## Architectural Commission Report

**Meeting Date:** Wednesday, March 20, 2013  
(Continued from the AC meetings on January 16, 2013)

**Subject:** **NESPRESSO**  
**320 North Beverly Drive**  
Request for approval of a façade remodel, sign accommodation for multiple business identification signs, and construction barricade graphic (PL1231996)

6 TYPICAL LED LIGHT FIXTURE  
Scale: N.T.S.

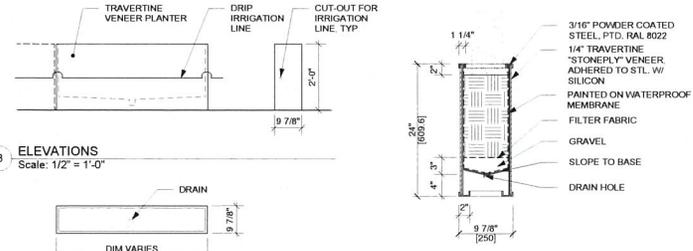
- A dwarf version of the Horsetail Rush is substituted for the previous cultivar. See sheet A4.5.
- The spacing between the joints of the upper identification sign are increased see sheet A3.1. The rendering and elevation are coordinated see sheet A3.1 and A5.2.
- Facade panel projection is indicated on A3.1.
- See plans and details 1/A2.1, 1/A4.4 and 7/A3.4 for the condition at the facade edges against the adjacent buildings.
- Please see the response above. Below the glass facade, the painted metal finish is recessed from the column faces against the adjacent buildings.
- Reflected ceiling plan is on 2/A4.4, downlight cut sheet is on 7/A4.6. Fixture will be trimless.
- 1/A4.4 indicates the 5' clearance.
